INDESIT company

WISL105XEX

F030566

Technical Documentation guidelines

N1040319FIG1

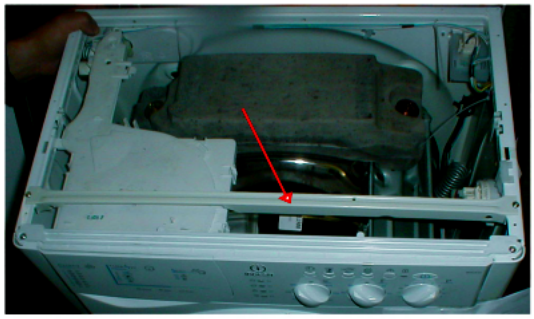
n1040319: Elimination of metal bar on INDESIT cabinets.

From serial no. 40223.0001 Indesit EVOII Washing Machines produced in the Comunanza - Brembate factory have been equipped with a wooden reinforcing strip on the top, whereas the metal bar on the cabinet has been eliminated.

The modified tops have the same Service code as premodification items (096937, 097617, 098440, 099929 and 097806).
When using the new top on a premodification appliance the metal bar (see N1040319FIG1) must be removed, whereas the old top can be used in place of the new one without any modification.
The new top can be used in place of the old one and vice versa; the Service code remains the same.

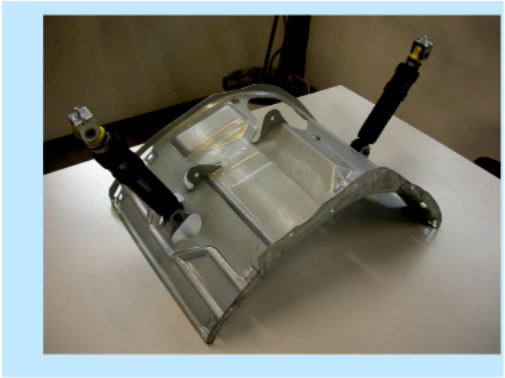
n1040325: New shock absorber fixing system with pin

From serial no. 40427.0001, shock absorbers have been fixed to the tank unit cradle with two 11 mm pins code C00110163 (see fig. 01 and 02 enclosed) in place of the 8 mm screws code 093750 and relevant locking nuts code 030443, on all washing machines and dryers produced in the Comunanza factory.
The items affected by this modification are:
1) The cradles have the same Service code, as they can be used in place of the new ones after widening the shock absorber fixing holes to a diameter of 10 mm.
Code 093848 - Tank unit cradle 46 lt
Code 093878 - Tank unit cradle 40 lt.

2) The new shock absorbers, with fixing bushing having no s/steel spacer, are not managed as they are interchangeable with the premodified items (make sure they are CIMA type, as the managed items), fixed with M8 screws code 093750 and related locking nut code 030443 (see figs. 05 and 06).
Code 093884 - Shock absorber 80 N
Code 093885 - Shock absorber 100 N

To remove the shock absorber from the tank, first extract the pin with a few hammer taps (see fig.03) until it is aligned with the tank bracket and then pull it out with a pair of pliers (see fig. 04).
(To refit the shock absorber use a new pin. Insert the pin until the toroidal edge is aligned with the bracket.)

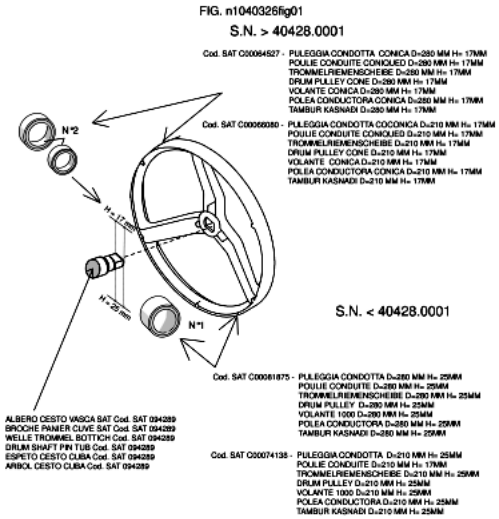
n1040326: Two-bearing mechanism on Slim range washing machines

From serial no. 40428.0001, all Slim range models produced in the Comunanza factory have been equipped with a two-bearing mechanism in place of the single-bearing one.

The Service codes of the new mechanism are:
Service code C00096186 - SEAL RING CV4;
Service code C00002591 - BEARING 20X47X14 6204 SKF;
Service code C00013563 - BEARING 25 X52 X 15 6205 - 2Z SKF;
Service code C00110340 - CROSS WITH SEAL RING (2C) SNELLA;
Service code C00094289 - EVO 40L TANK SLIM (1-C) > (2-C)EVOII;
Service code C00094290 - OUTER- SET 40 L.(1-C)>(2-C)EVOII;
Service code C00064527 - DRIVEN PULLEY CONE D=280 MM H= 17MM;
Service code C00066080 - DRIVEN PULLEY CONE D= 210 MM H=17 MM.

The tank assembly with the new two-bearing cross has the same Service code as the single-bearing one (C00094289); the latter will be available until stocks run out.
When replacing the tank, make sure that the value H (17 mm or 25 mm) of the basket cross shaft corresponds to the value H of the pulley (see Fig.001).

The following premodified items will continue to be used:
Service code C00026298 - BEARING BA2B 633667 30X60.03X37;
Service code C00039667 - SEAL RING;
Service code C00074137 - CROSS WITH SEAL RING;
Service code C00081875 - DRIVEN PULLEY D=280MM H=25MM;
Service code C00074138 - DRIVEN PULLEY D = 210MM H=25MM;
Service code C00026299 - SEEGER RING SB 60X1,5.

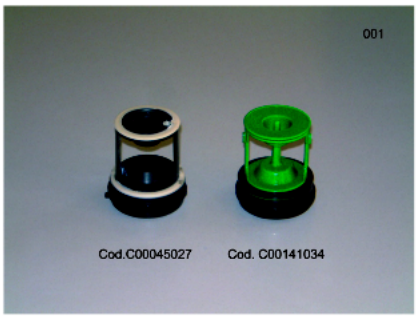
n1040359: Polar White Factory 80 (Comunanza)

From serial no. 50315.0001, the new "Polar White" colour is used on all washing machines and washer-dryers produced in factory 80 in place of White 27.
The third last number of the Industrial Code given on the rating plate of the modified models is 9 (e.g. 80286390900).
To determine the new Polar White codes, it is necessary to know the industrial code or serial number of the appliance being repaired.
The new items, which bear the initials "PW" in place of "B27", are not aesthetically interchangeable with premodification items as the whites are different. Both colours will be available for some time.
The items affected by this modification are:
Body, rear panel, top, control panel, handles, buttons, knobs, knob disc, door and plinth.
